Submission on VNI West Consultation Report – Ted Woodley 4 April 2023

I wish to submit comments and questions on the [VNI West Consultation Report](#), dated 23 Feb 2023.

VNI West is the abbreviated term for the **Victoria to NSW Interconnector, West** route

Figure 1 – Generation difference with and without VNI West (Consultation Report Fig 11)

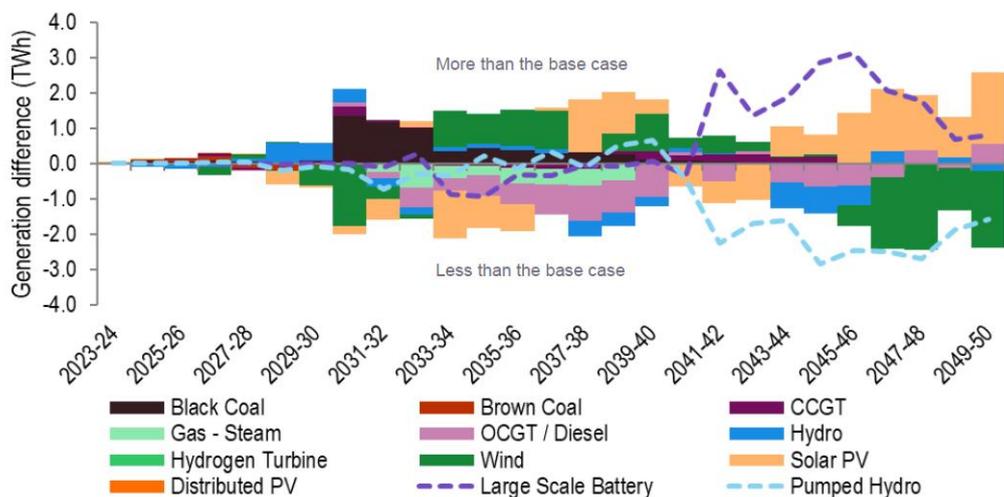
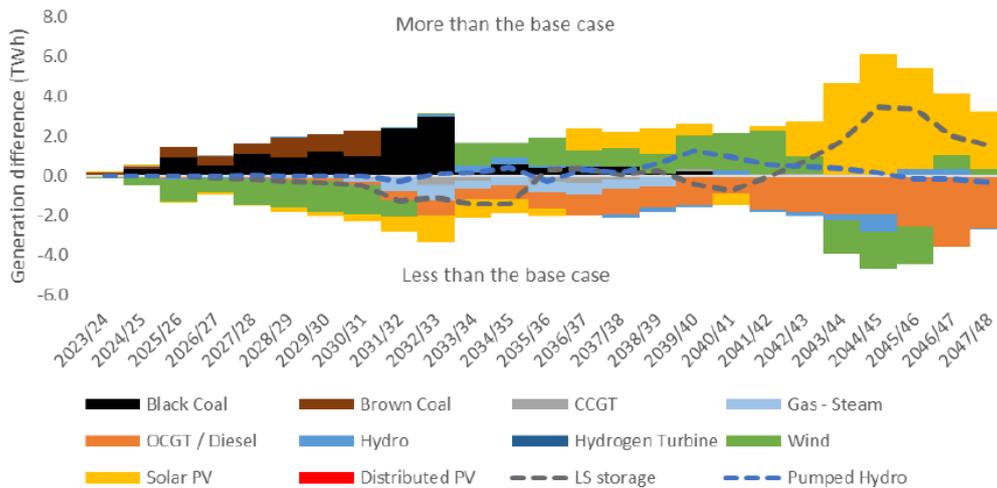
The Consultation Report does not provide reasons for the significant changes in generation output (Figure 1) compared to the PADR (Figure 2).

How does a decision to build VNI West result in less wind output (dark green bars in Figure 1) in the years before it is commissioned (2026-27 and 2029-30 to 2031-32)? Also, why would wind output be significantly less from 2045-46 to 2049-50 due to VNI West being built fifteen years earlier?

Similarly, why does VNI West result in less solar PV output (light ochre bars) in most years from 2027-28 to 2034-35?

Figure 1 depicts additional black coal generation (black bars) if VNI West is built compared to the Base Case. This additional coal generation is forecast to occur from 2030-31 to 2038-39, up to eight years after VNI West is commissioned.

Previously, the PADR forecast even greater additional black and brown coal generation both before and after VNI West’s commissioning (Figure 2). Why is it now forecast that only black coal output will increase, not brown coal as well, with its lower marginal cost of production?

Nevertheless, how is it conceivable that VNI West would result in additional coal fired generation for eight years after VNI West is commissioned? Isn’t this the opposite of what might be expected or hoped for?

Why does the amount of hydro output vary if VNI West is built?

- extra hydro generation (dark blue bars in Figure 1) from 2028-29 to 2030-31
- less hydro generation in 2025-26, 2031-32 to 2032-33, 2037-38 to 2039-40 and 2043-44 to 2045-46

The PADR (Figure 2) also forecasted differences in hydro output if VNI West is built, but less so and not before VNI West's commissioning.

Figure 4 – Cumulative gross benefits from VNI West (PADR Fig 8)

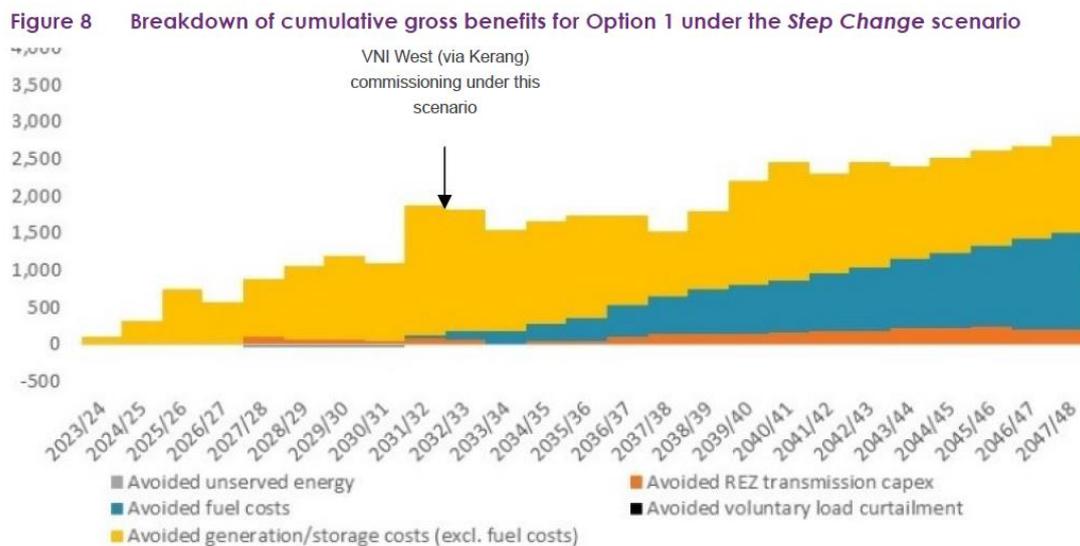
No reason is provided for the almost \$1 billion increase (35%) in gross benefits compared to the PADR.

The PADR estimated cumulative gross benefits from building VNI West of \$2,795 million by 2047-48, primarily from avoided generation/storage costs (\$1,295 million) and avoided fuel costs (\$1,300 million). The proportionate contributions from avoided generation/storage costs and avoided fuel costs were one:one (see Figure 4).

The significantly higher proportion of avoided generation/storage costs is evident when comparing Figure 4 (ochre bars vs dark blue bars) with Figure 5 (purple bars vs green bars).

Figure 5 – Cumulative NPV gross benefit from VNI West (Submissions Report Fig 1)
left: PADR presentation, right: annualised presentation

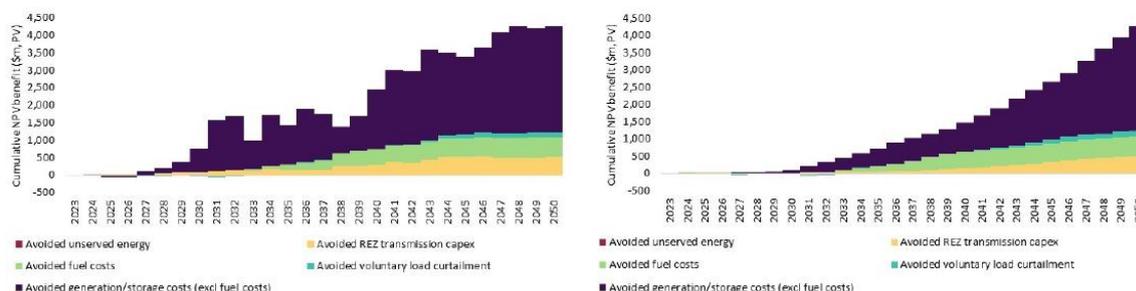
However, avoided generation/storage costs have increased \$1,651 million (130%) and now outweigh avoided fuel costs five:one. They actually exceed the total benefits in the PADR.

Why have avoided generation/storage costs increased \$1,651 million (130%) compared to the PADR?

On the other hand, why have avoided fuel costs reduced by \$731 million (56%)?

The left diagram of Figure 5 shows *“the entire capital costs of these plant in the year avoided to highlight the timing of the expected market benefits capacity difference”*.

(purple bars) from not building so much renewable generation and storage prior to VNI West's commissioning in 2031 appears to be approximately \$1.6 billion NPV.

Is this the magnitude of costs avoided by the implausible deferrals of renewable projects?

Figure 6 – Snowy 2.0 Generating Capacity Factor PADR (AEMO/TransGrid Dec 2022)

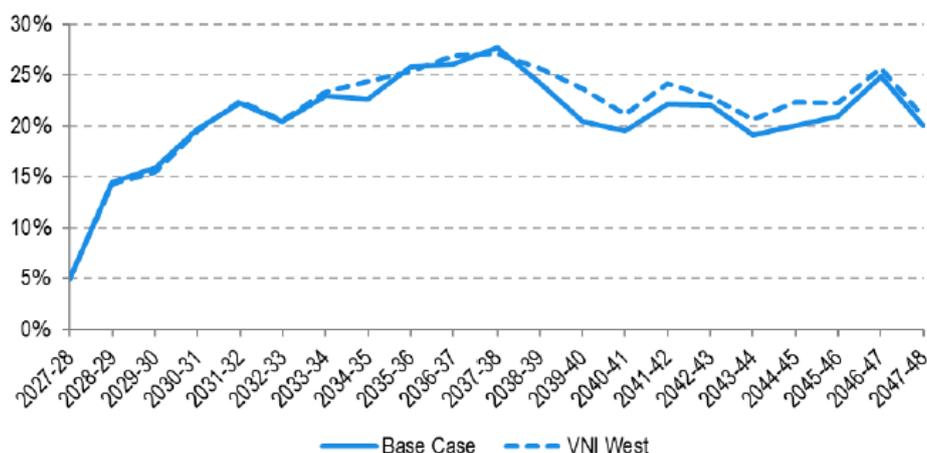
As shown, the PADR estimated that VNI West would enable a very marginal increase in Snowy 2.0 use of a few percent.

The PADR forecast Snowy 2.0's capacity factor to continue in a range of 20% to 27% for the modelling period, till 2047-48 (Figure 6).

Figure 7 – Snowy 2.0 capacity factor with and without VNI West (Consultation Report Fig 3)

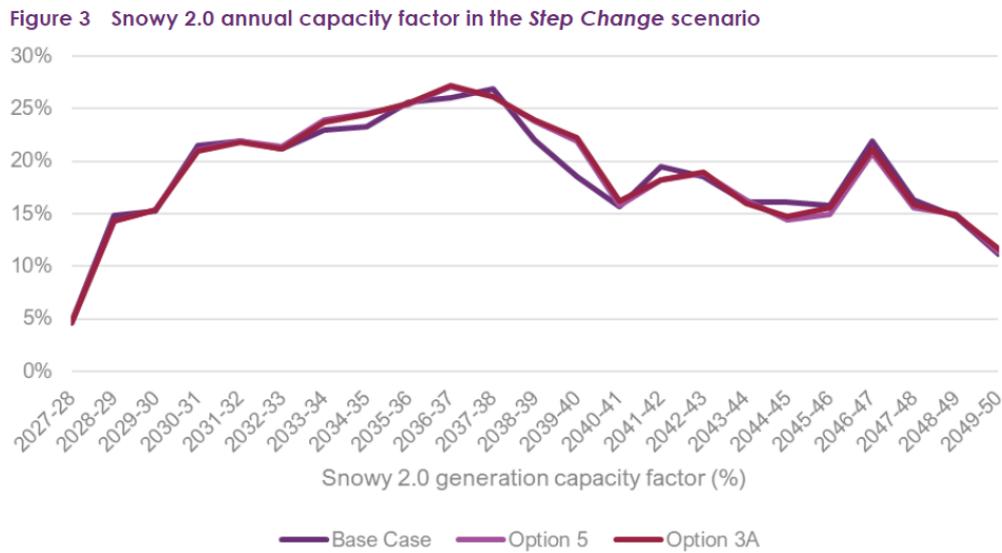
The latest modelling confirms that VNI West will have no impact on Snowy 2.0’s utilisation – the difference shown in Figure 5 of less than 1% is less than the errors inherent in such long-range modelling.

However, the Consultation Report forecasts Snowy 2.0's capacity factor dropping off from a peak of 27% at the end of the 2030's to 11% by 2050 (Figure 7).

No explanation has been provided for this decline by two-thirds.

And it is telling to see that even at a capacity factor of 11%, VNI West has no impact on Snowy 2.0's utilisation.

Though it would appear from Figure 7 that no matter when Snowy 2.0 is commissioned and whatever its operational capacity factor, VNI West will have no impact on its utilisation, compared to the Base Case.

Even though the latest modelling now forecasts that VNI West will have no impact on Snowy 2.0's capacity factor and utilisation, the unrealistically high estimate of 21-27% during the 2030's (Figure 7) impacts the modelling.

Figure 8 – Snowy 2.0 Generation/Pumping and Buy/Sell Price (Snowy Hydro FID)

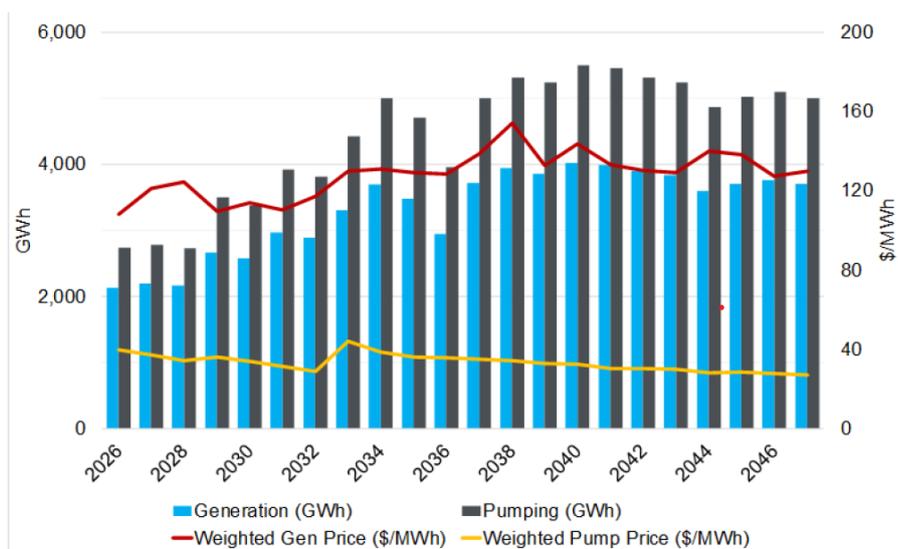
This combined capacity factor of 54% was the basis for the Snowy 2.0 Business Case.

It is noted that this level of operation is much higher than envisaged in the earlier [Snowy 2.0 Feasibility Study, Dec 2017](#), which stated that *“in any given year prior to 2040, the Project will be operated at full capacity for less than 87 hours/year”*.

Figure 9 – Snowy 2.0 Electricity Production Projections (Snowy Hydro, AEMO)

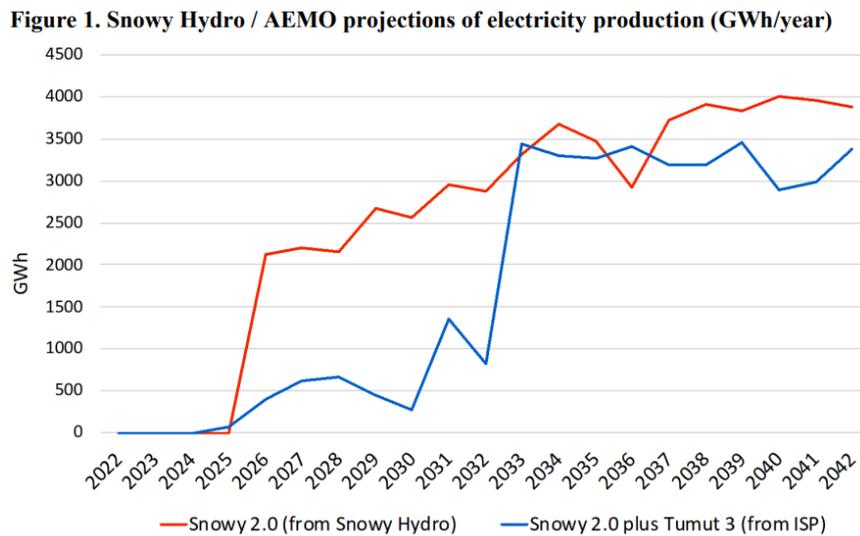
Of course, the Snowy 2.0 capacity factor would be higher if Snowy 2.0 assumed a greater share of generation and vice versa. Tumut 3 has a slightly higher efficiency than Snowy 2.0, suggesting that it may be given priority.

It is noted that, whilst the future will be entirely different to the past, the pumping capacity factor for Tumut 3 has averaged less than 2% since its commissioning 50 years ago – in some years it did not pump at all.
